MIL-C-11693C  
 AMENDMENT 5  
 15 October 1991  
 SUPERSEDING  
 AMENDMENT 4  
 6 August 1982

CAPACITORS, FEED THROUGH, RADIO-INTERFERENCE REDUCTION, AC AND DC  
 (HERMETICALLY SEALED IN METAL CASES),  
 ESTABLISHED AND NON-ESTABLISHED RELIABILITY  
 GENERAL SPECIFICATION FOR

This amendment forms a part of Military Specification MIL-C-11693C,  
 dated 8 October 1971, and is approved for use by all Departments  
 and Agencies of the Department of Defense.

FIGURE 1. Insulation-resistance curve for characteristics -M-, -K-, -E-, and -W-

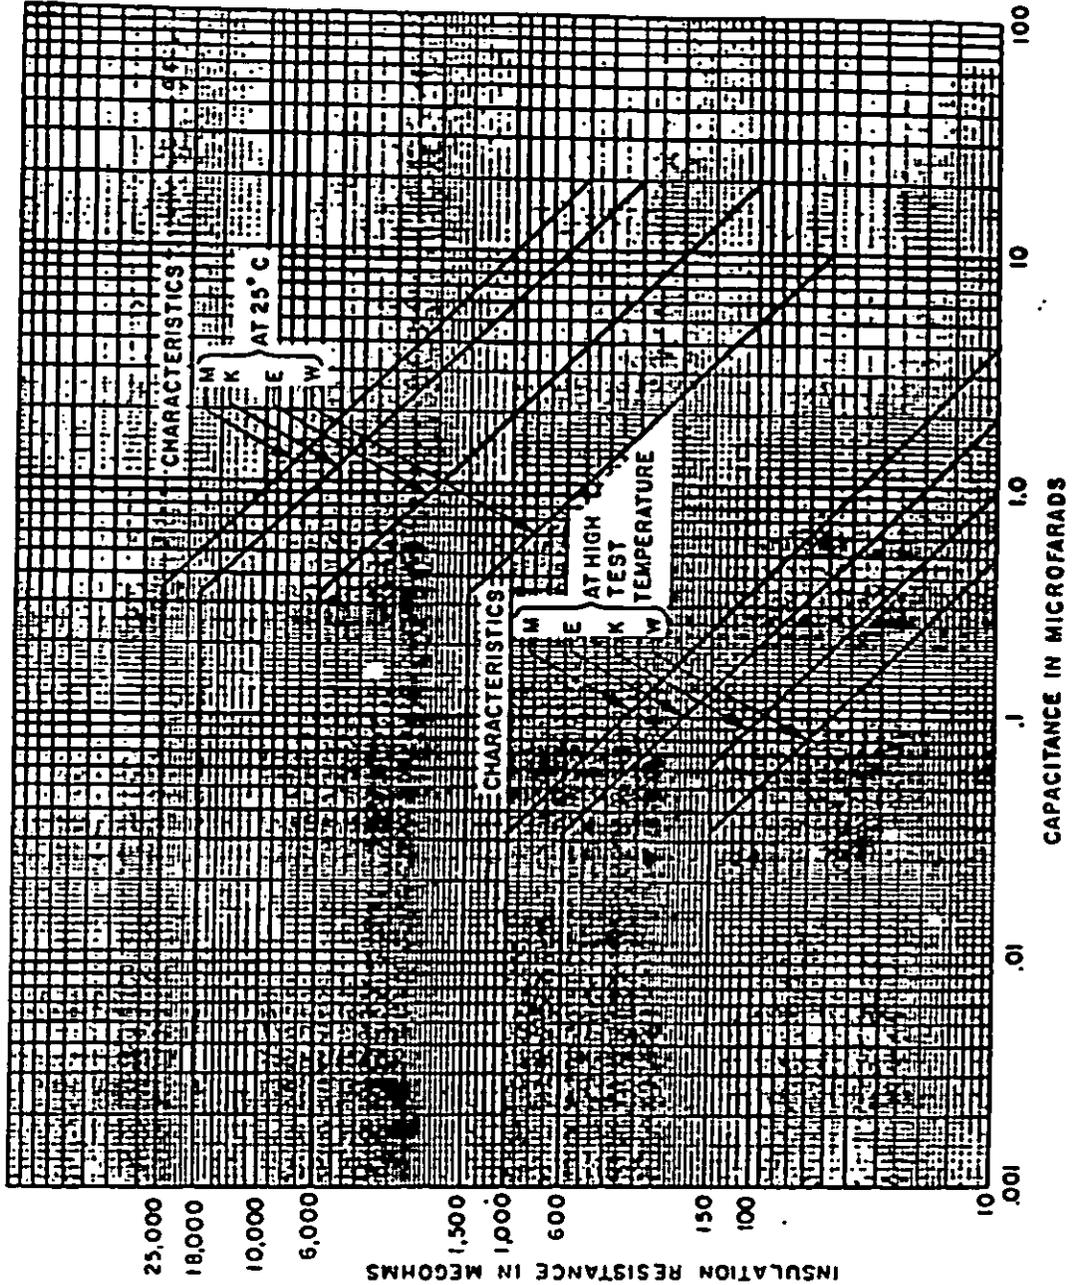
FIGURE 1: Delete and substitute new figure 1 as printed on page 3 of this amendment.
